# Plan finalisation report – PP 2020-2142

158 - 168 Queen Street, 1 Carberry Lane and 3 & 11 Cordeaux Street, Campbelltown.

February 2022

Figure 2 The proponents Option 1 – source: The Departments Urban Design team

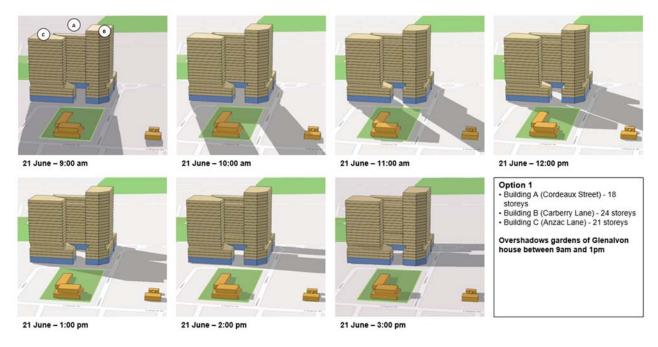
The Department's analysis indicates that the proponent's Option 1 would result in overshadowing of the gardens of Glenalvon from 9am till 1pm (**Figure 2**). The impact being caused by building A (Cordeaux Street – 18 storeys), building B (Carberry Lane – 24 storeys) and building C (Anzac Lane – 21 storeys). The proposed RSL site development adjoining Queen Street at 45m did not result in overshadowing of the curtilage of Glenalvon (**Figure 3**).

The proposal submitted for finalisation does not provide adequate urban design analysis and testing to support the additional height and FSR proposed or, in the Department's opinion, adequately identify heritage impacts from an urban design perspective from the three building elements (Buildings A, B and C) to the south. The Department has made several post-exhibition amendments to address State agency objections and the urban design deficiencies detailed. The amendments are as follows:

The Department has resolved not to rezone 1 Carberry Lane and 3 & 11 Cordeaux Street, the portion of the site which proposed an increase from 32m to 85m in height. Amendments to the planning controls applying to portion of the site can be progressed in a future new planning proposal.

This is in response to the concerns raised in submissions that an 85m height on part of the site would result in overshadowing of adjacent Glenalvon House and its curtilage, a State heritage item.

Figure 4: Portion of site (red shading) for rezoning as post exhibition amendment

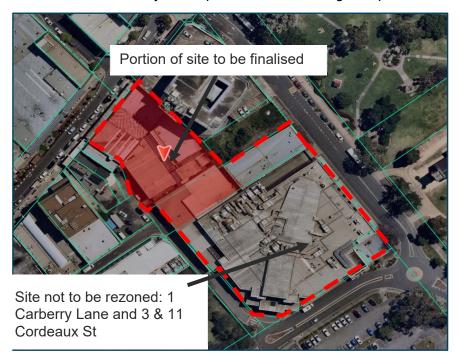
The portion of the site at Lot 1 DP 558320 and Lot 5 DP 1167855, 158-168 Queen Street, with the proposed 45m height will be finalised by the Department. This will facilitate a new RSL club and hotel. A detailed summary of the post exhibition changes is provided below:

- Proceeding with finalising the rezoning at Lot 1 DP 558320 and Lot 5 DP 1167855 (158-168, Queen Street) with a 45m height limit as per the proposal
- Inserting a site specific clause for employment generating purposes associated with the new RSL and hotel building under Part 7 of the Campbelltown LEP
- Identify the site on the Clause Application Map within Campbelltown LEP
- Removal of the minimum FSR control for employment floor space as the site can only be developed for the purpose of a registered club or hotel or motel
